Flight Procedures Cover Page	Task Action: FLIGHT CHECK	Task Type: Segment	Estimated Chart Date: 11/30/2023	APWS Task ID: 7B3C10E2F5EC4973AF23250049A440FB	APWS Project ID: F6D287F6096240EB97EB407CF1F316E8
Procedure: T242 BRW VDME, AK TO TKA VDME, AK		Enroute: YES	Specialist: Gibson, Taylor		Agreement Number:
Airport ID:			Airport City:		State:
Facility ID:	Facility Type:	Flight Inspection Remark Type: New FC Slot

DOCKET NUMBER 19-AAL-67

7/7/2023: THIS IS AN UPDATED COPY OF THE FORM DEVELOPED ON 9/1/2022

242 BRW VDME, AK
TO TKA VDME, AK
SCALE: 500,000

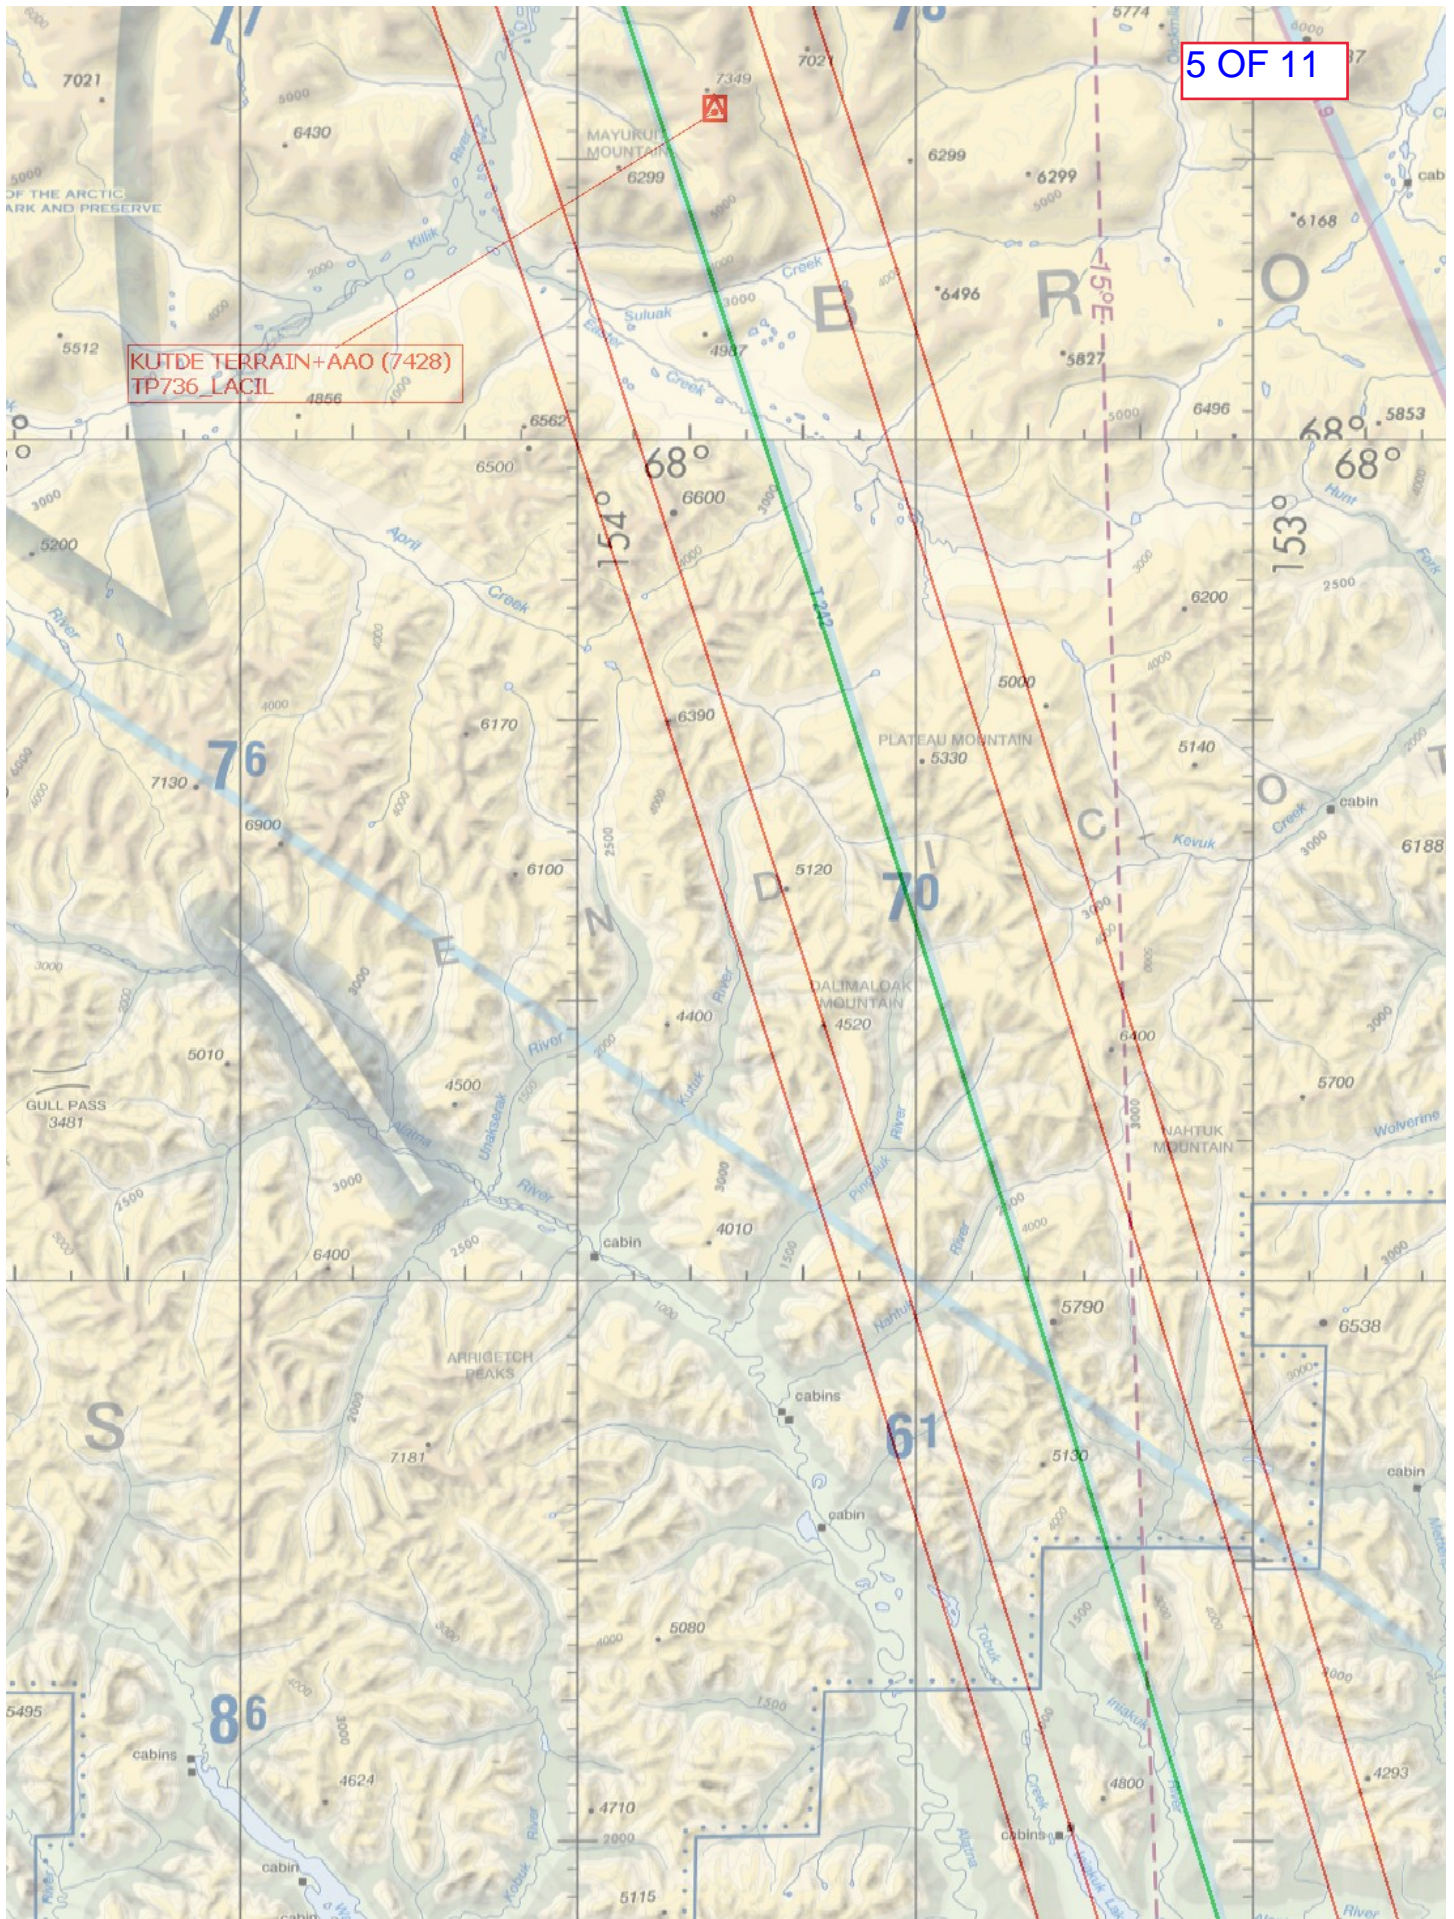
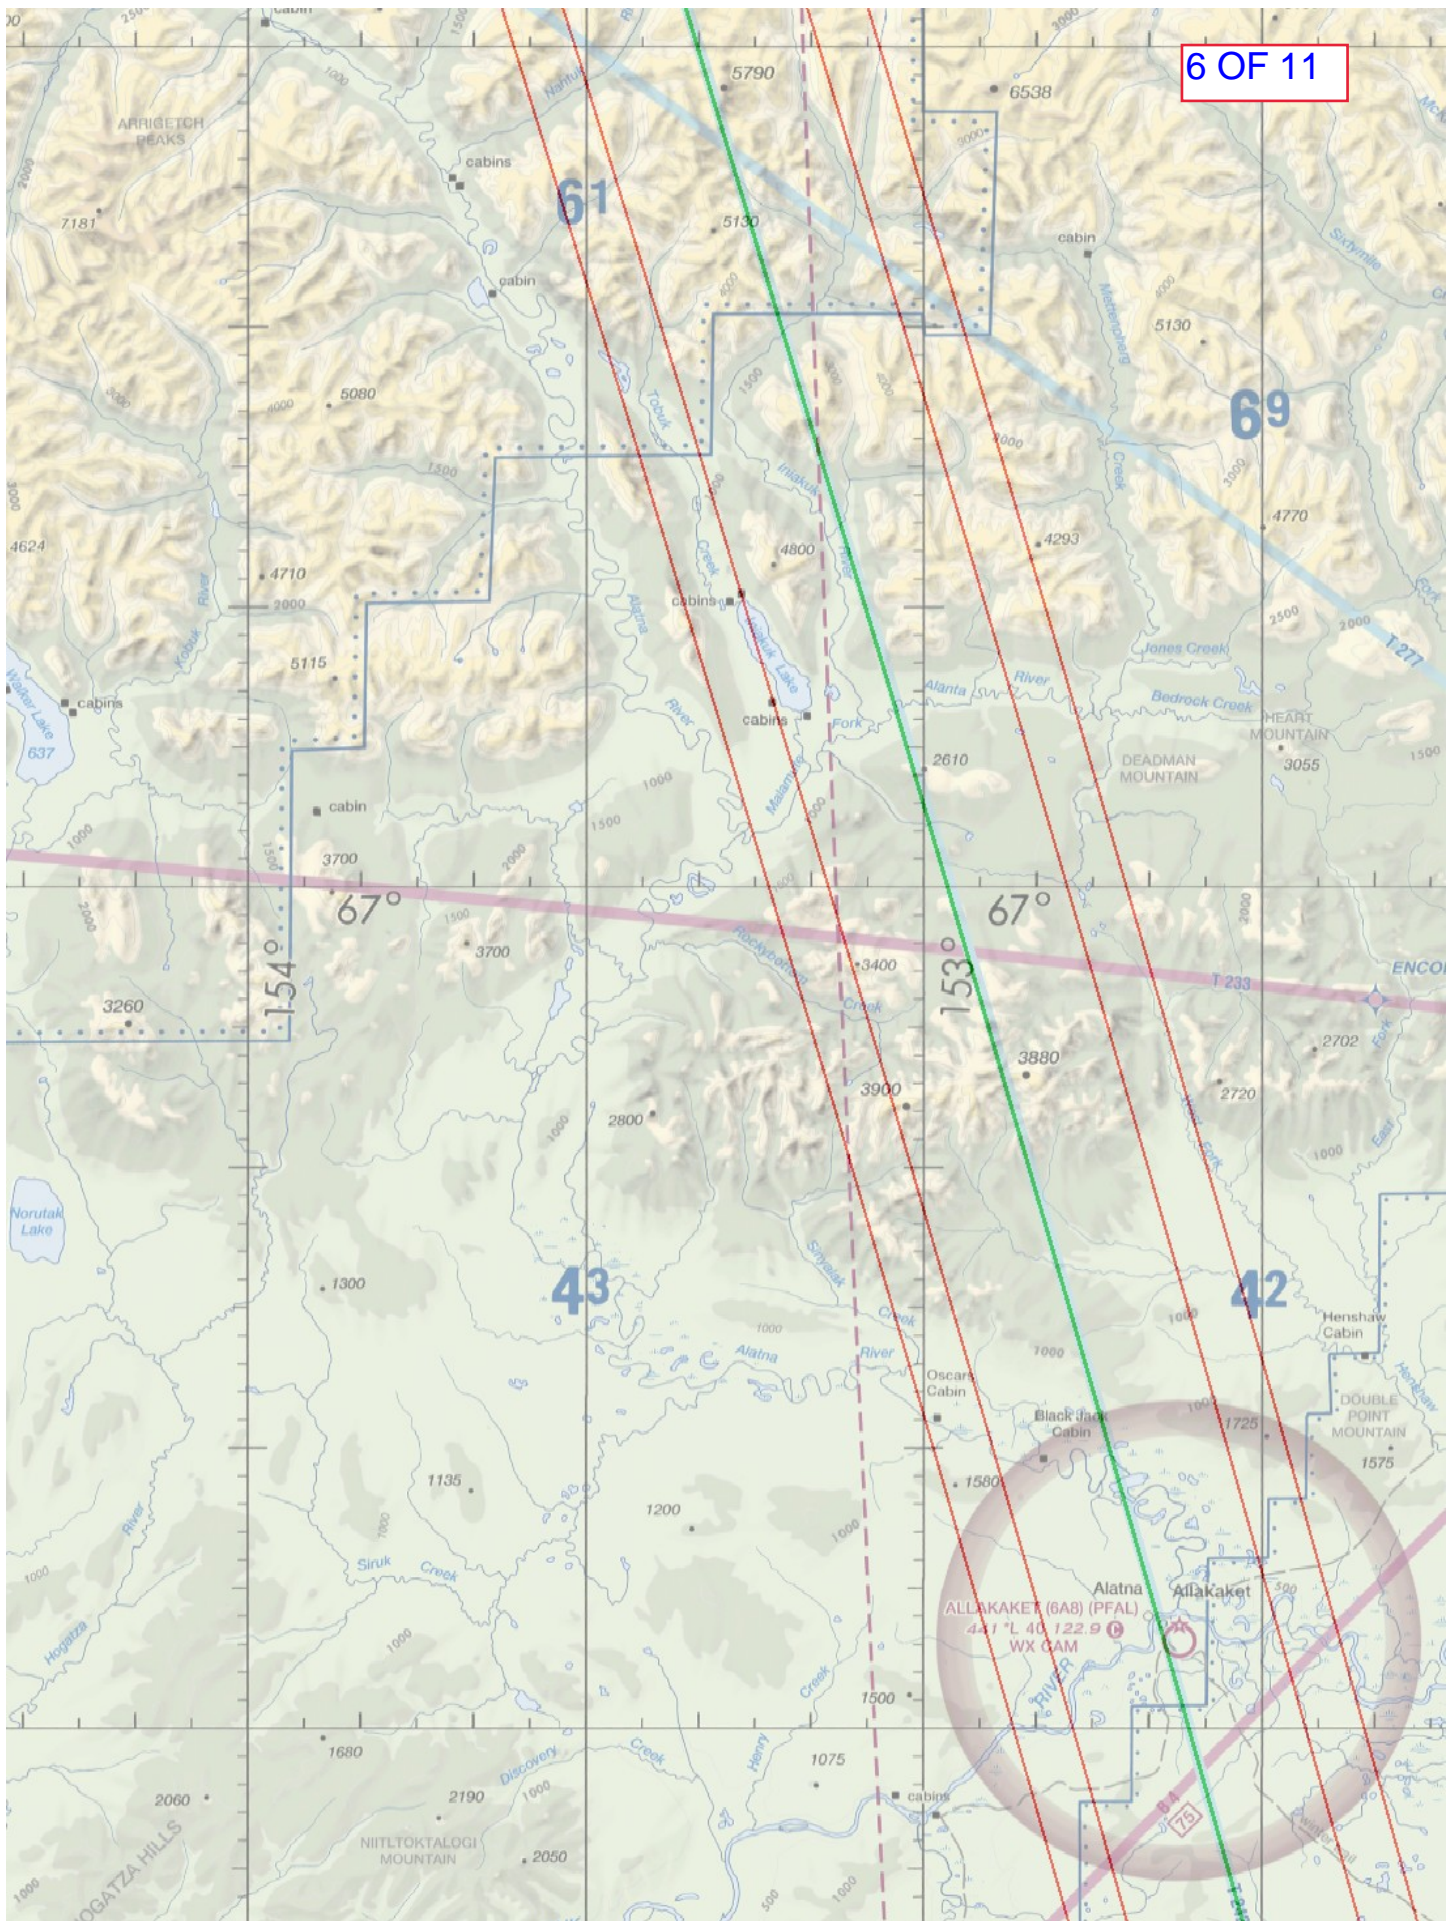
1. CHANGE MRA FROM 9500 TO 13500, MEA 13500 - PER FLIGHT CHECK REPORT
